LAYOUT	A. Tologo	INSP 4			
INSP 2		INSP 5			
INSP 3		INSP 6			
ISSUE DATE:	6/9/2006	PER	RMIT		P 525104
APPROVAL DATE:	6/15/0	6 IND	EXED #04-331753		A 520109 - A
	ON-S		DISPOSAL SYST	ГЕМ	
			IEALTH DEPARTM ONMENTAL HEAL		230
Hatfields Equi	pment		IS PERMITTED TO	INSTALL	⊠ ALTER □
ADDRESS: PO	Box 519, A	nnapolis Junct	ion PHONE NUM	MBER: 30)1-854-6172

o Snarp Road		PERTY OWNER:	Trinity Quanty Homes, Inc.
PACITY (GALLONS):	1500	OUTLET BAFF	LE FILTER REQUIRED
CAPACITY (GALLONS):	n/a	COMPARTMEN	NTED TANK REQUIRED 🛛
ROOMS:	5		
R BEDROOM:	180		
TRENCH REQUIRED:	115	_ HOUSE SERVE	ED BY PUBLIC WATER

· RE: 3650 Sharp Road

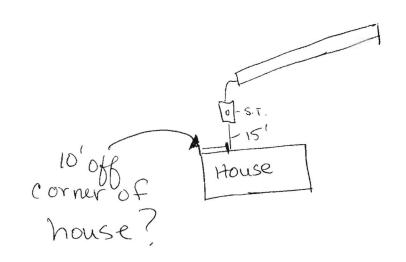
Kew, Iknow as much as what is already infile I sent copy of existing system to Hatfields-drew it since Microfische copy difficult to read. that's all I know. It appears they Will need to upgrade system for 5 bodrns total. Hope 4 mis helps-

2' sidewall 180 x 5 = 900 - 2 = 450 x ,57= 256.5 2565 total length w/ 100' existing =

* 156.5' -> New trench weedled & tank upgrade. *

\$ 57' -> New trench need w/ . 36 sidewall + New tank & z compart.
